Broad Street Vacation

Meeting Summary

November 19, 2015

Urban Design Merit

Figure 7: Proposed open space plan

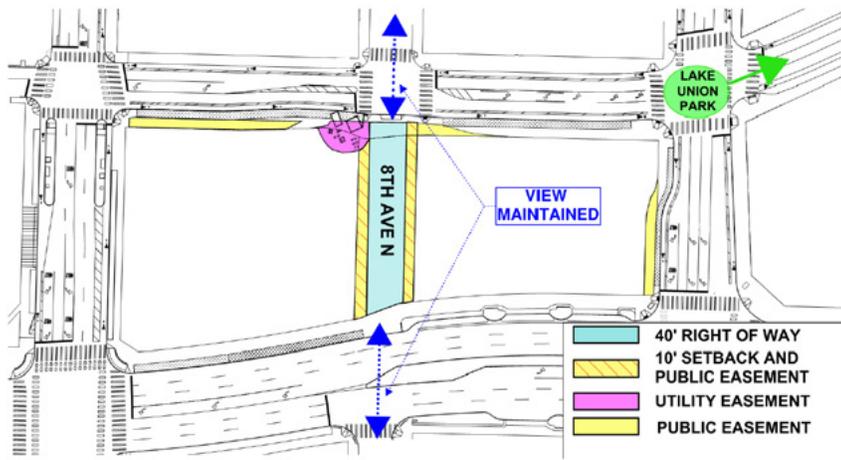
The Commission agrees that open space guidelines should regulate the relationship designated open space has within the public realm. Detail should be given to the location of open space so that it does not feel like an afterthought. Commissioners also agree guidelines should address the building's form as to let an adequate amount of light and air into the designated open space and 8th Ave. ROW.

1. Consider qualities of open space in in the design guidelines as it relates to the public realm
2. Establish Roy St. as the preferred point of site access for vehicles
3. Address equity and affordability while developing planning and design guidelines

Figure 8: Proposed vehicular site access with vacation

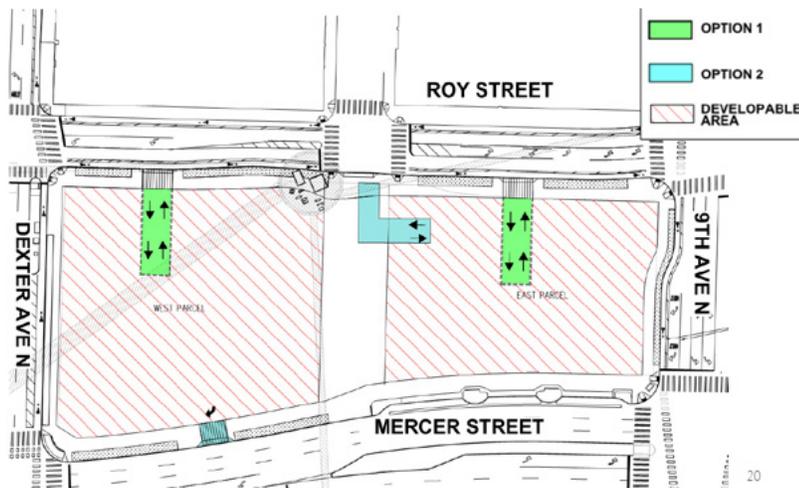
The Commission appreciated the level of detail regarding building massing within each scenario, but questioned how the project design will invite pedestrians into the space. Commissioners recommended the guidelines include an additional ROW along 8th Avenue through the project site in order to create a greater sense of connectivity. The SDC encouraged the design team to incorporate a pedestrian crossing at the intersection of Mercer Street and 8th Avenue and also recommended that option 2 for vehicular access be removed from the plan.

1. Develop a detailed plan for providing a pedestrian crossing at the intersection of 8th Avenue and Mercer Street
2. The commission does not support the use of the 8th Ave N right of way for vehicular access to or around the site
3. Prior to council approval, the design team shall develop design guidelines for SDC review
